Environmental Impact Assessment process for the lifetime extension of Paks NPP

Answers to the study of „Umweltbundesamt”, to the statements of the provincial authorities of Lower-Austria, Burgenland and Wien, Greenpeace, Global 2000, the social organisations of Wien Platform called as “Future without nuclear energy” and to the opinion of Austrian private persons

January 2006

Ageing management programs for the components of the plant

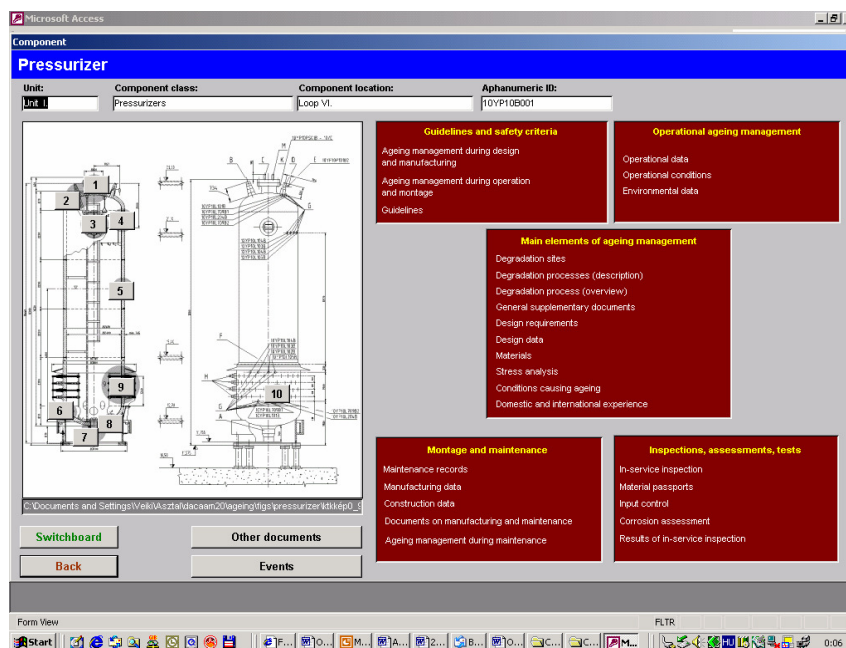
Furthermore, the ageing of many other systems, structures and components can also be of safety significance. A comprehensive ageing management program is required and should be presented in the documentation.

Availability of the ageing management program should be demonstrated and it should be described during the nuclear safety licensing procedure by the plant, the requirements of which are specified by the point 2.4.2. of the Volume I of NSR.

The lifetime of a plant is determined by the lifetime of the components that have important safety related or operational functions. They cannot be replaced or only at so great cost that is not reasonable and economical. It is obvious that until the end of the planned lifetime, even on

the last day of operation, all equipment and the whole plant should meet the safety requirements.

In 1993 the system of periodical renewal of operating licences was introduced in Hungary by Periodic Safety Reviews in accordance with the European nuclear safety regulation practice. During the reviews performed ten yearly it should be proved as a condition of the operating licence that despite the ageing processes the safety-related components are operable. This requirement is supported by the systematic ageing management activity introduced ten years ago and its extension for continuously increasing scope of components.
